UNITED STATES PATENT AND TRADEMARK OFFICE

APPLICATION NO.	FILING DATE	FIRST NAMED INVENTOR	ATTORNEY DOCKET NO.	CONFIRMATION NO.
10/798,643	03/10/2004	Eric A. Jacobsen	P18403	6694
25694 7590 01/08/2007 INTEL CORPORATION C/O INTELLEVATE, LLC P.O. BOX 52050 MINNEAPOLIS, MN 55402			EXAMINER CHAUDRY, MUJTABA M	
			ART UNIT 2133	PAPER NUMBER
SHORTENED STATUTORY PERIOD OF RESPONSE		MAIL DATE	DELIVERY MODE	
3 MONTHS		01/08/2007	PAPER

Office Action Summary

combination Sum-Product (SP) soft decision decoding and Bit-Flip (BF) hard decision decoding
Fig. 13B

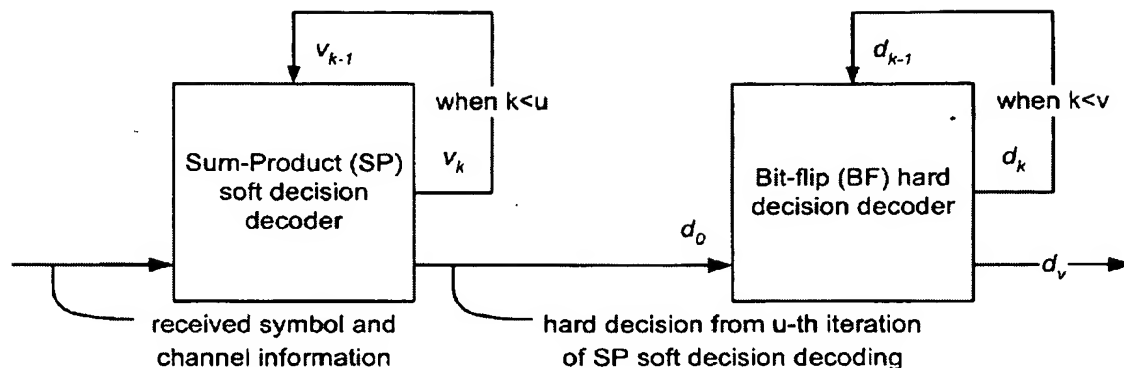
As per claim 1, Shen et al. (herein after: Shen) teaches a decoding method (i.e., paragraph 0011, lines 1-3) comprising: decoding information received at a network device (i.e., Figure 1, satellite receiver with decoder) by applying a first algorithm iteratively until a stopping criterion is reached (i.e., Figure 13B, SP soft-decision decoder and paragraph 0143); and further decoding the information using a second algorithm different than the first algorithm (i.e., Figure 13B, BF hard decision decoder and paragraph 0143). The Examiner would like to point out that the first decoding is processed for all $k < u$, which is the stopping criteria for the first SP decoder and the second decoding is processed for all $k < v$, which is the stopping criteria for the second BF decoder (i.e., paragraph 0143). See Figure 13B:

Fig. 3C

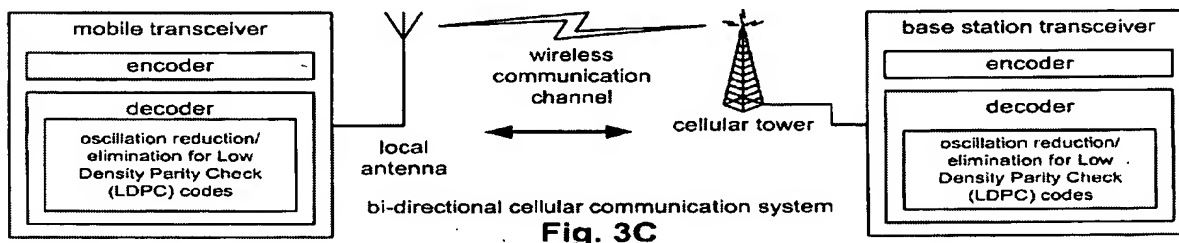
As per claim 4, Shen teaches (i.e., Figure 3C, below) the network device includes a radio frequency (RF) transceiver. The Examiner would like to point out that the communication is to/from a cellular tower, which operates at radio frequencies and therefore the transceivers are RF. By definition, RF refers to that portion of the electromagnetic spectrum in which electromagnetic waves can be generated by alternating current fed to an antenna.

Fig. 5B

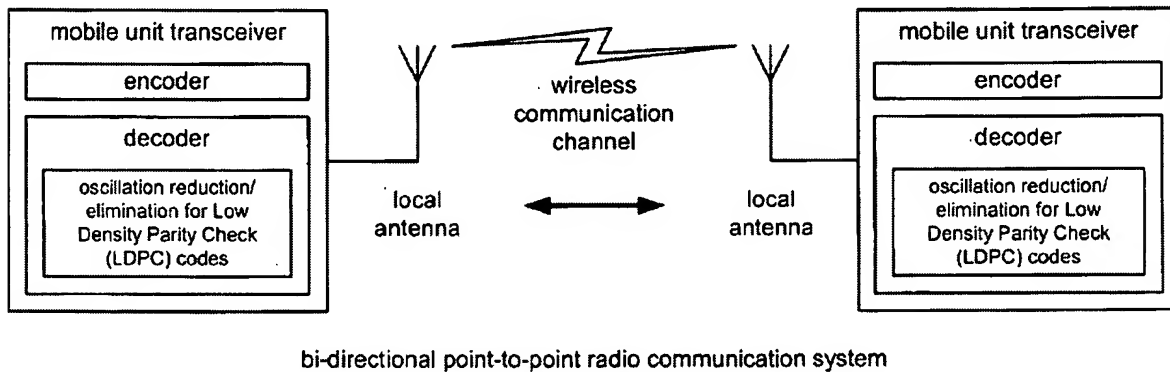
As per claim 5, Shen teaches (i.e., Figure 5B, below) the RF transceiver comprises a wireless local area network (WLAN) transceiver. The Examiner would like to point out that a

WLAN, by definition, is a wireless local area network, which is the linking of two or more devices without using wires. The mobile unit transceivers shown in Figure 5B are part of a local area network that are connected wirelessly.

As per claim 19, Shen teaches (i.e., Figure 5B, above) the RF transceiver comprises a wireless local area network (WLAN) transceiver. The Examiner would like to point out that a WLAN, by definition, is a wireless local area network, which is the linking of two or more devices without using wires. The mobile unit transceivers shown in Figure 5B are part of a local area network that are connected wirelessly.
